Appendix I of RNTPC
Paper No. S/YL-ST/612A

**APPLICATION FOR PERMISSION
UNDER SECTION 16 OF
THE TOWN PLANNING ORDINANCE
(CAP.131)**

**Section 16 Planning Application for Proposed Public Utility Installation
(Underground Cables) and Associated Filling and Excavation of Land**

**Section 16 Planning Application No. AY1-ST/612 for Proposed Public Utility Installation
(Underground Cables) and Associated Filling and Excavation of Land****Installation of the Proposed 132kV and 11kV Cable Circuits
Connecting with Ho To West Substation in Lok Ma Chau Loop Development Area
Along Ha Wan Tsuen East Road, Lok Ma Chau Road, Tun Yu Road and Local Tracks
(Government Land in D.D. 96 and 99)****- Further Information No. 1 -**

Attachment A – Indicative Alignment of Proposed Cables (SUBJECT to this application only)

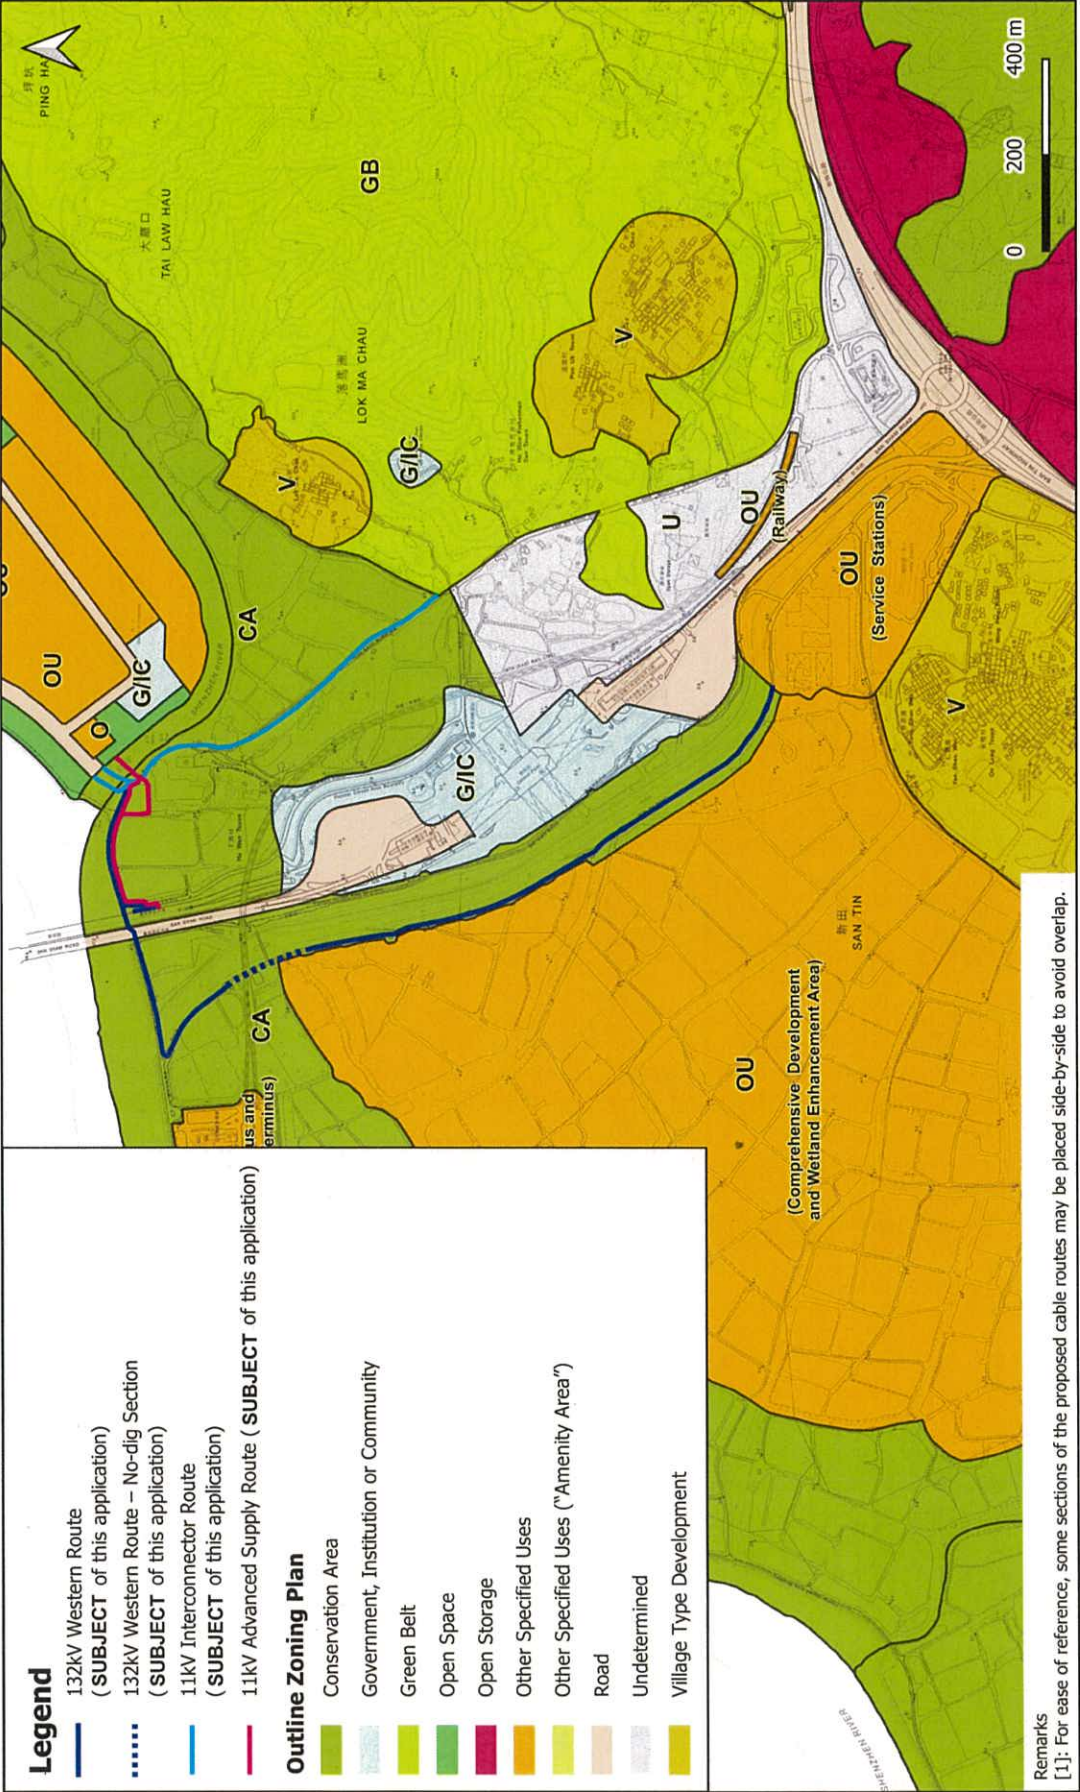
For the TPB members' ease of reference, a diagram (**Attachment A** refers) has been prepared to illustrate the sections of the proposed cable routes that are subject to this planning application and is required planning permission from the TPB.

For the TPB members' ease of reference, a diagram (**Attachment A** refers) has been prepared to illustrate the sections of the proposed cable routes that are subject to this planning application and required planning permission from the TPB.
